ECE/TRANS/WP.29/GRSP/44
23 January 2009

Working Party on Passive Safety

**REPORT OF THE WORKING PARTY ON PASSIVE SAFETY
ON ITS FORTY-FOURTH SESSION
(Geneva, 10 - 12 December 2008)**

Figure 1

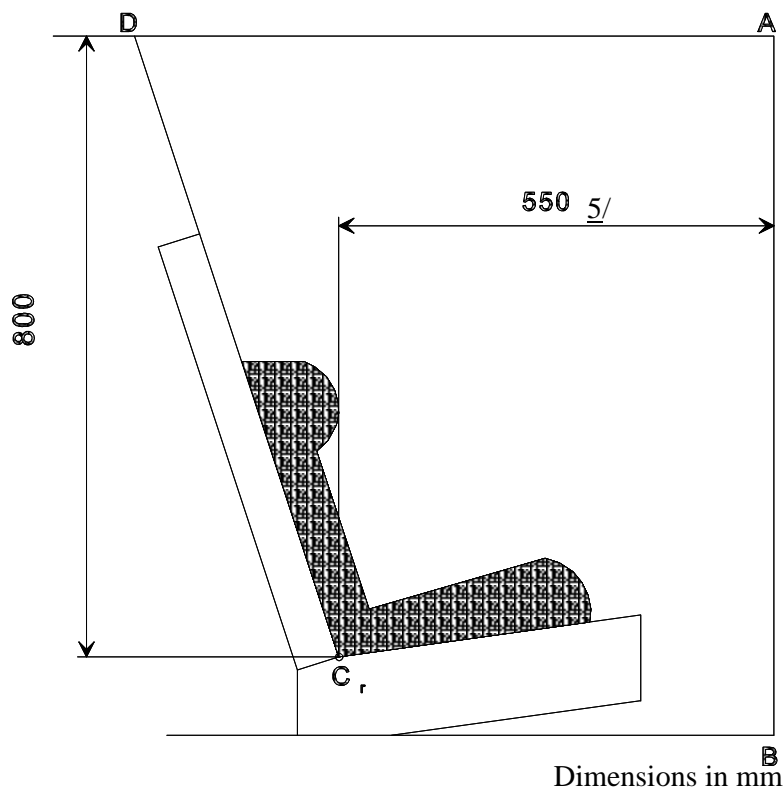
Paragraph 7.1.4.4.1.1., figure 1, insert a reference to a footnote 5/ to the 550 dimension, and insert the corresponding footnote 5/, to read:

5/ For the purpose of the test specified in paragraph 7.1.4.1.10.1.1., this dimension shall be 500 mm."
